ADDENDUM NO. 1

Cheek Community Sewer Improvements – Cheek Phase III

Bid No.: IFB 13-006/KJS

d.p. Job No. 112-29B

PLAN
 STA 69+00 TO STA 79+00

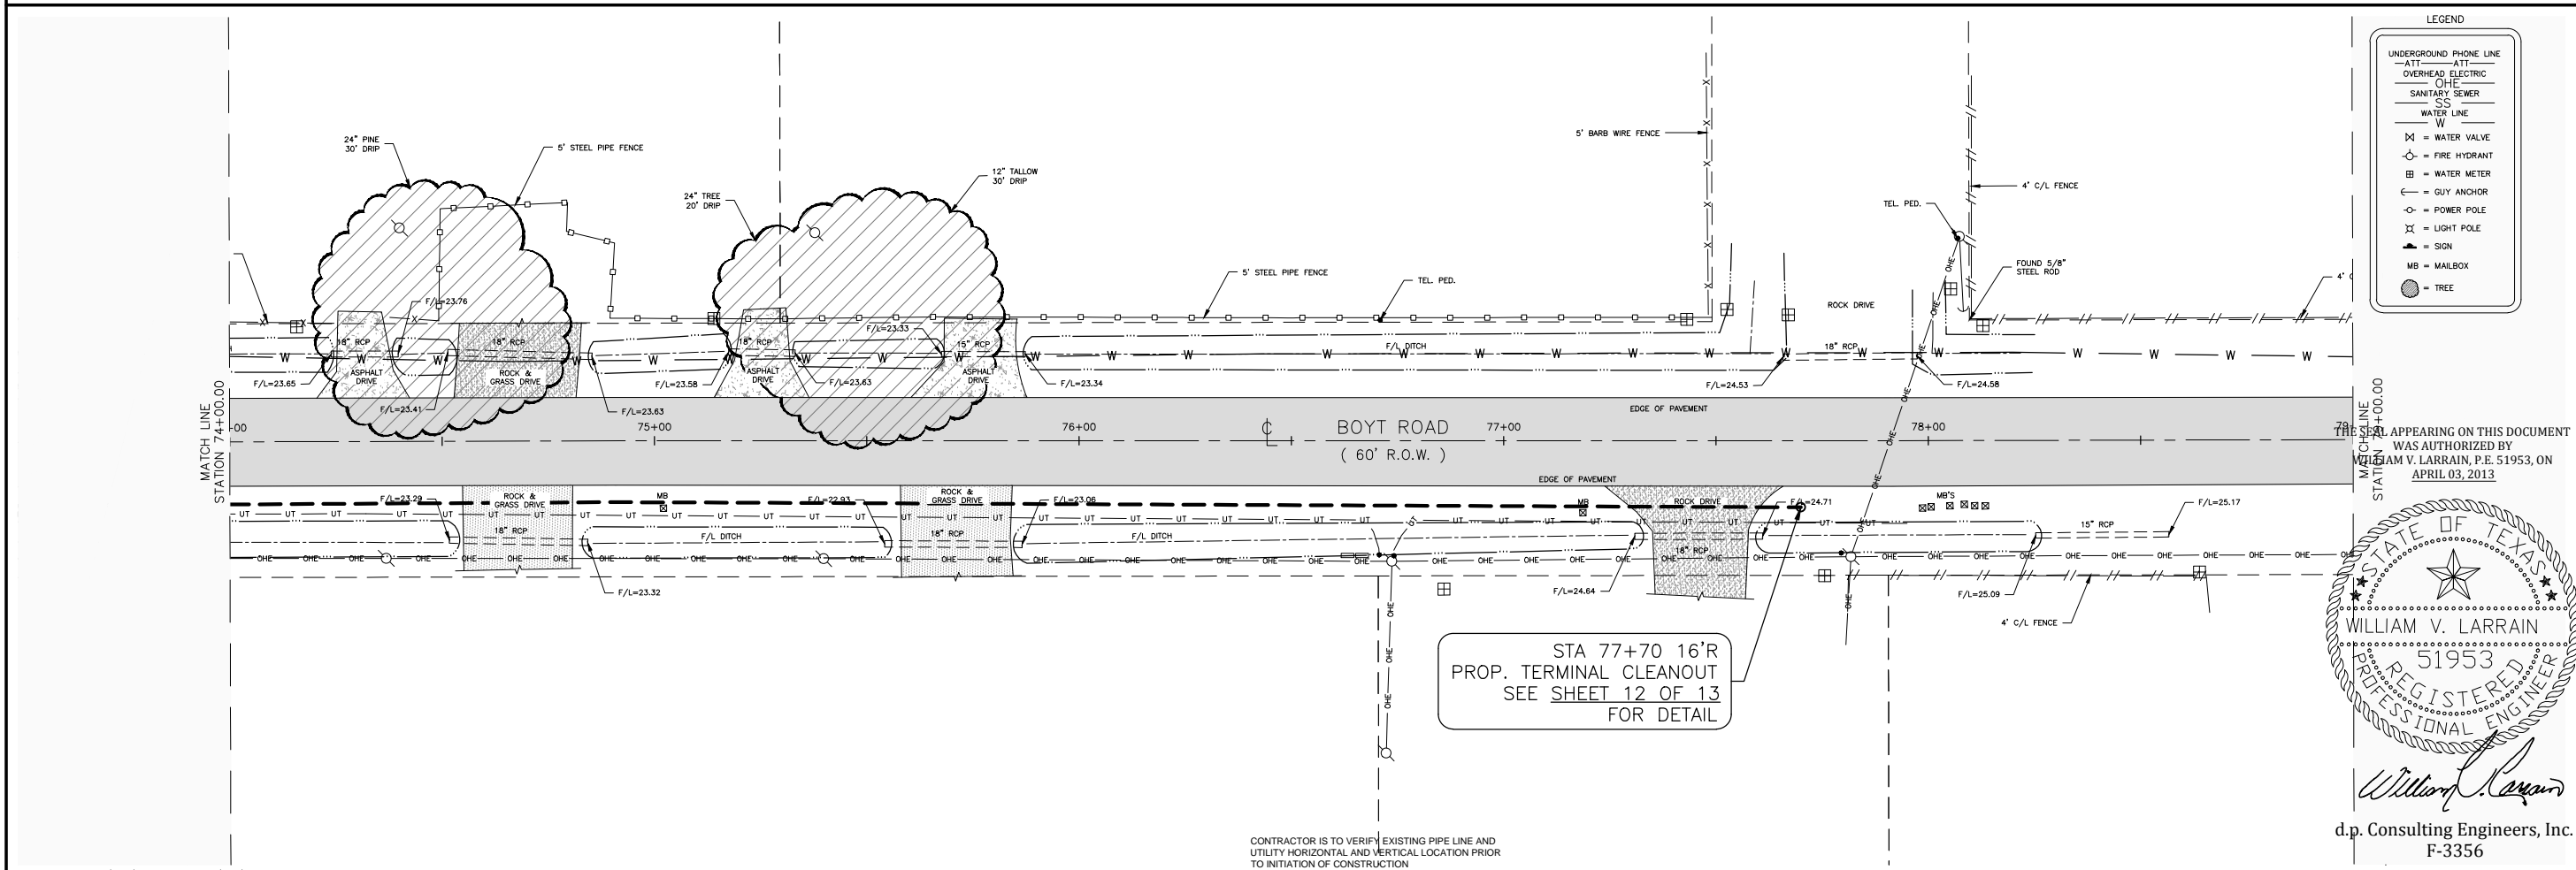
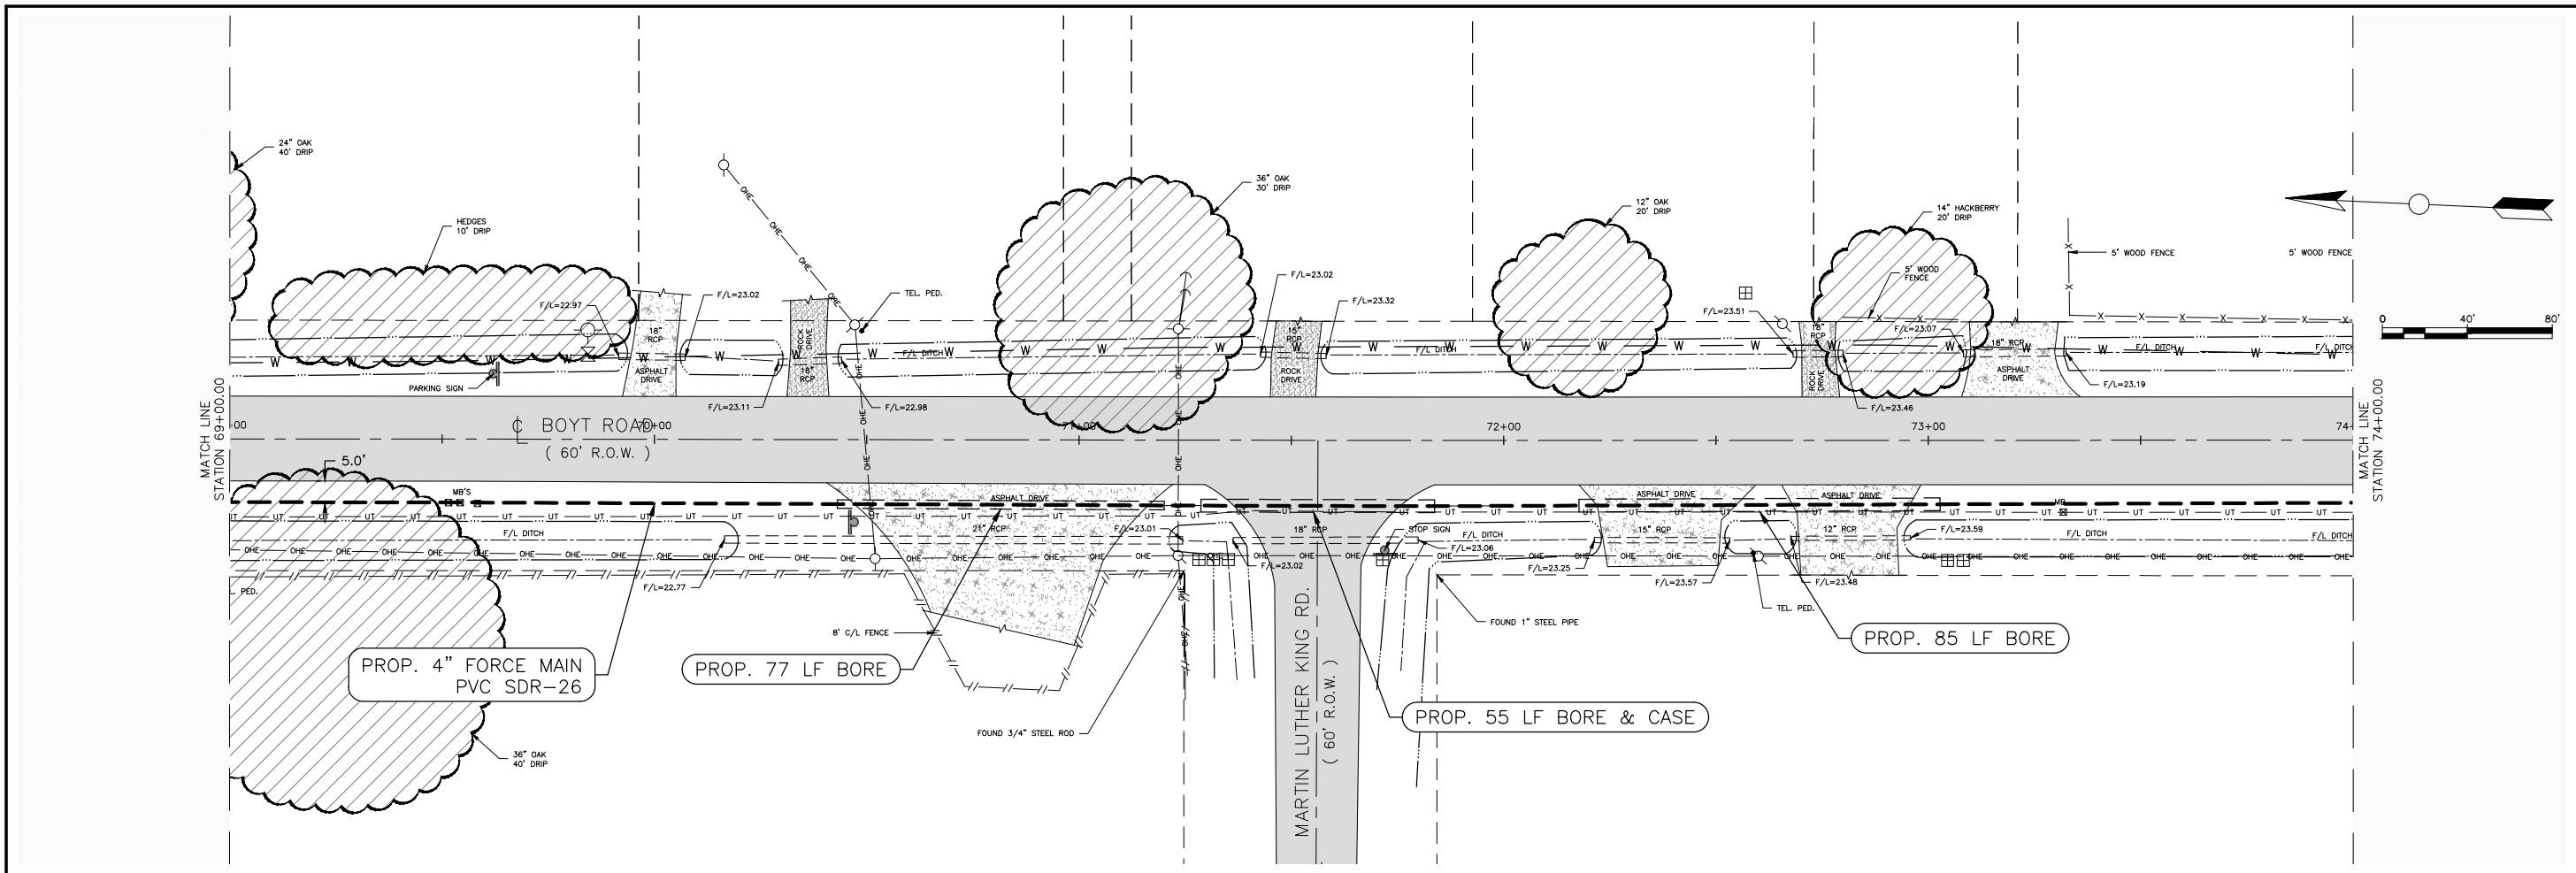
- (a) Replace **Plans Sheets 9 and 12** with revised **Plan Sheets 9 and 12** attached.
- (b) **Plan Sheet 9A**, attached, has been added to the Construction Plans to show profile details of “Bore & Casing” under the County Roads.

Clarification: Plan Sheet-9 includes additional force mains along Boyt Road. A pipe bedding detail for mainline force main is added to the Plan Sheet 12.
